Appendix A: WSCC Correspondence

WEST SUSSEX COUNTY COUNCIL CONSULTATION

TO:	Mid Sussex District Council FAO: Steven King
FROM:	WSCC – Highway Authority
DATE:	10 February 2026
LOCATION:	Land At Borde Hill Lane Haywards Heath West Sussex
SUBJECT:	DM/25/3129 Outline planning application for the erection of up to 125 dwellings, together with the provision of landscaping, open space, and associated development works, with access from Balcombe Road. All matters reserved except for access.
DATE OF SITE VISIT:	4 February 2026
RECOMMENDATION:	More Information Required

Design Audit Proposed Access Design

Date	06.02.25	Scale	1:500	Drawn	NM
Drawing No.	SDP-XX-XX-DR-D-352	Revision	P3

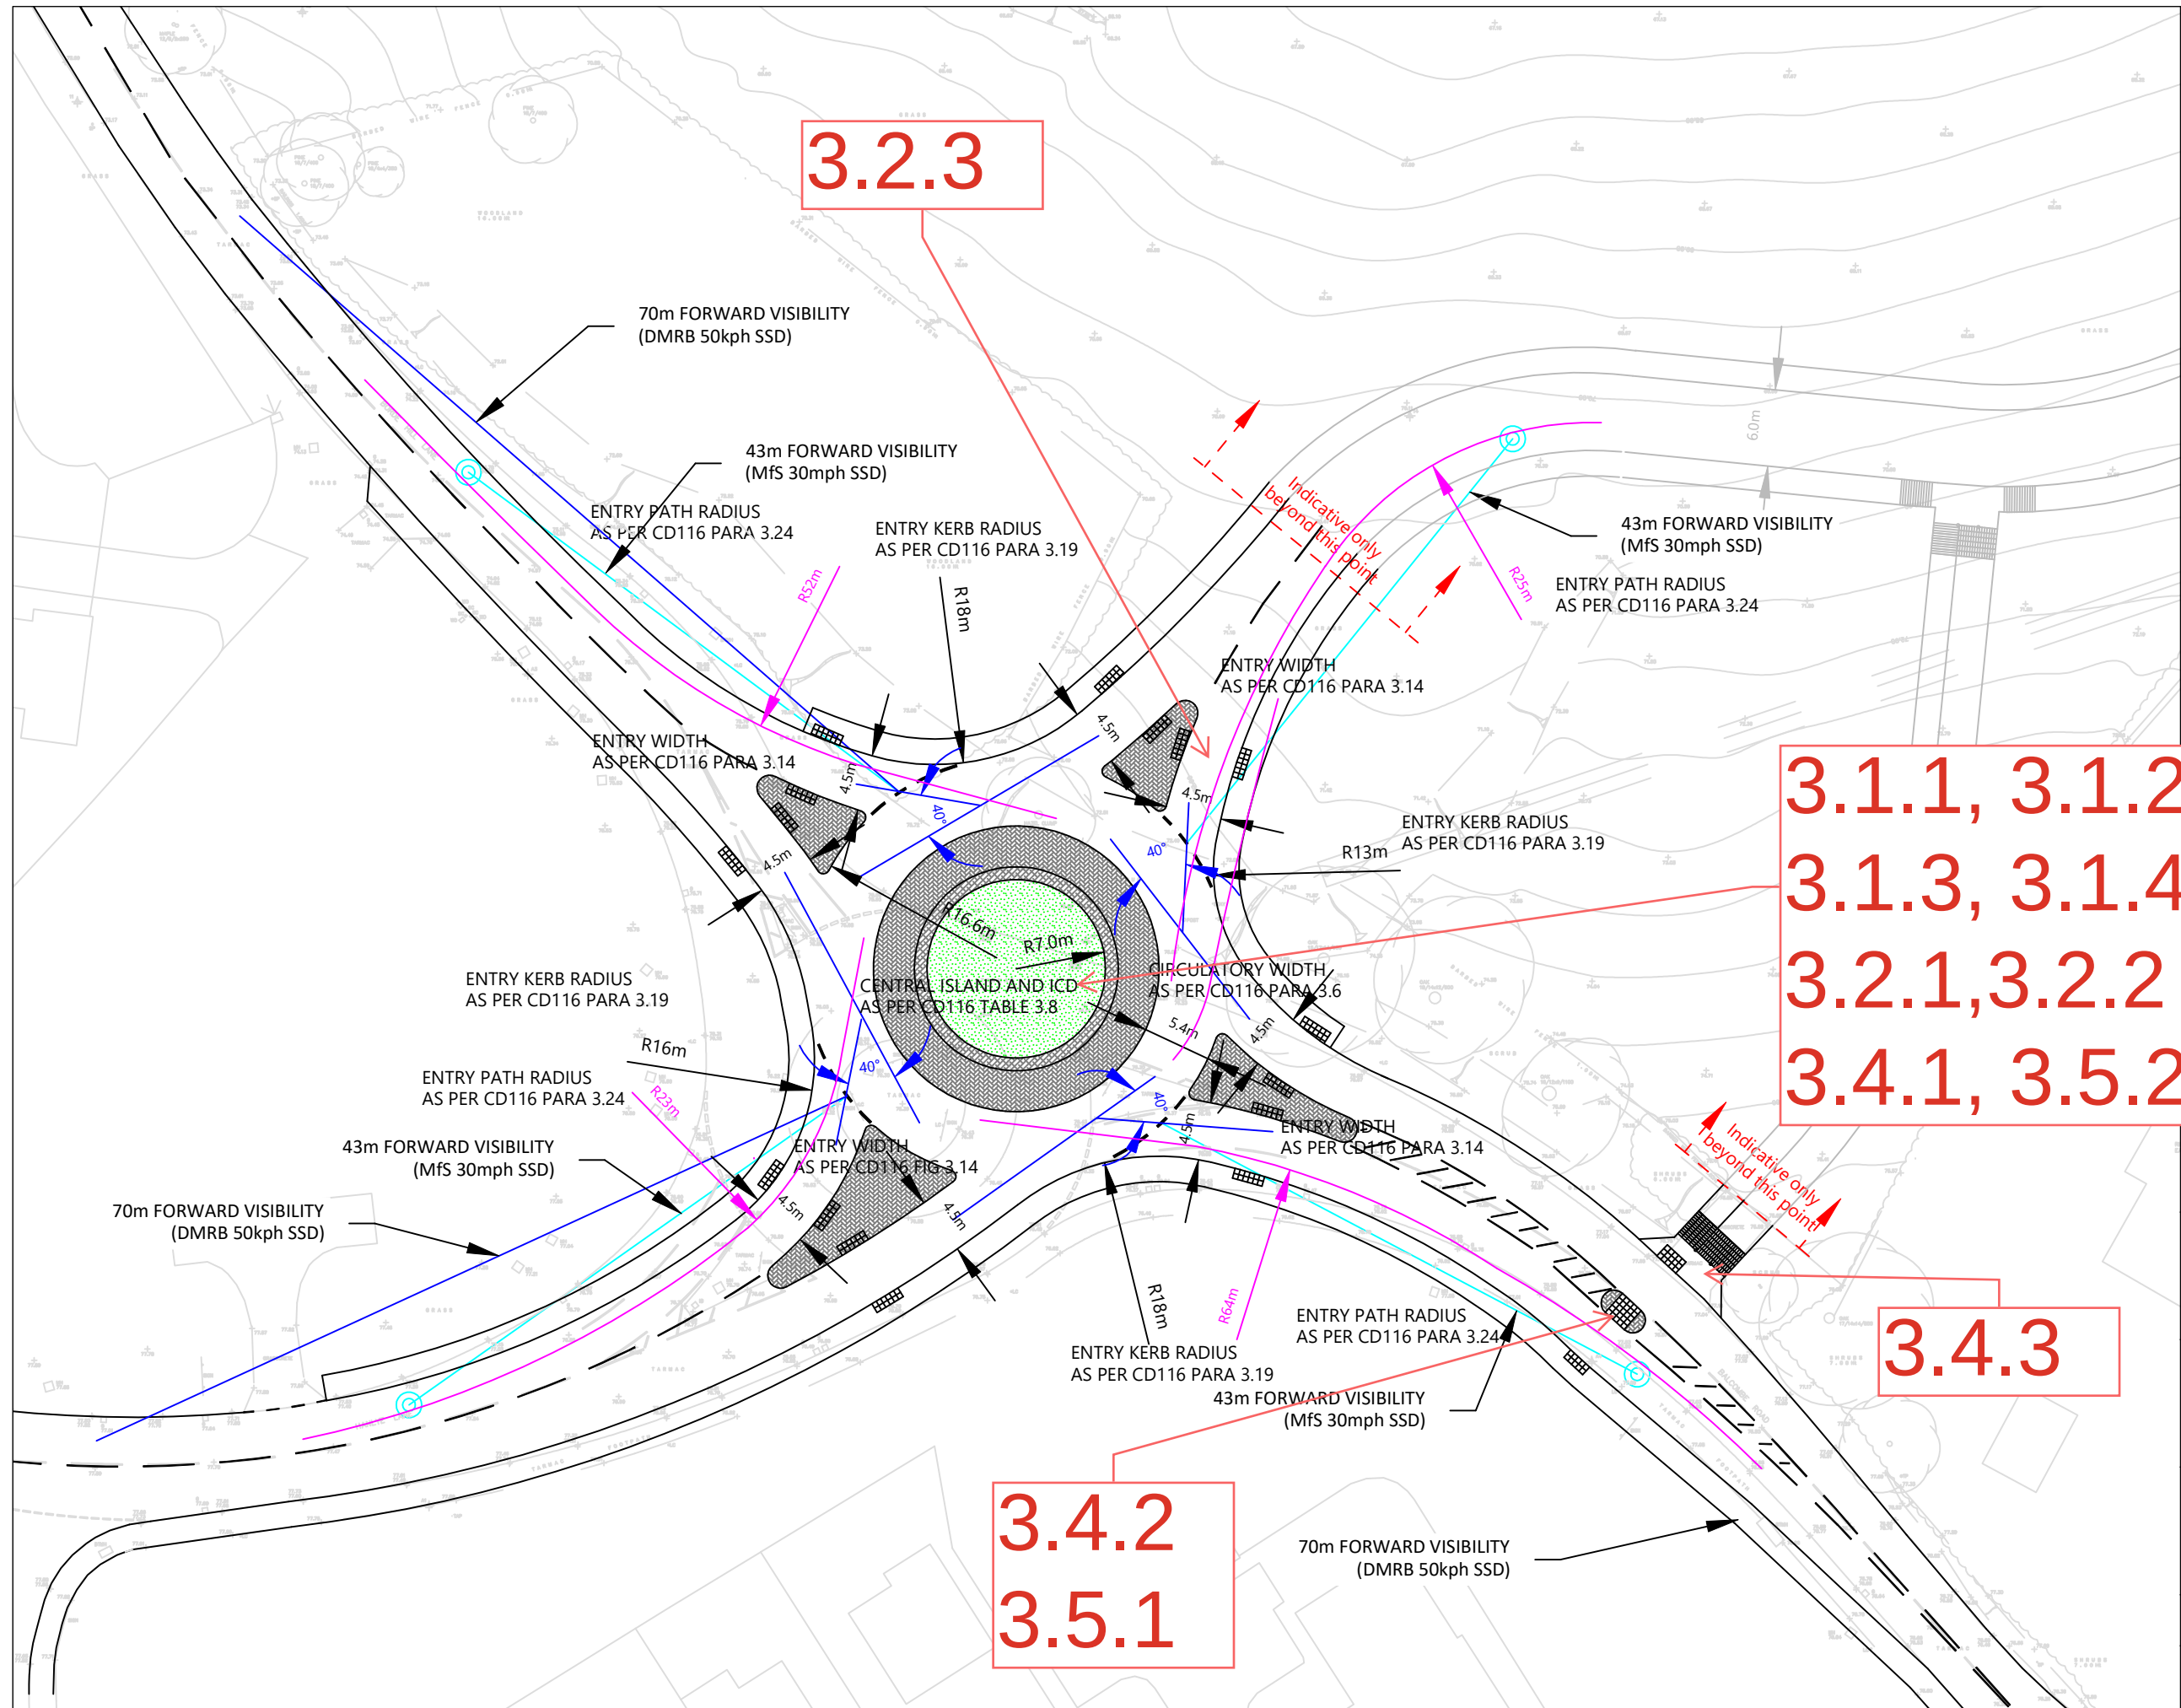
Plan attached showing the locations of the problems identified as part of this audit (location numbers refer to paragraph numbers in the report).
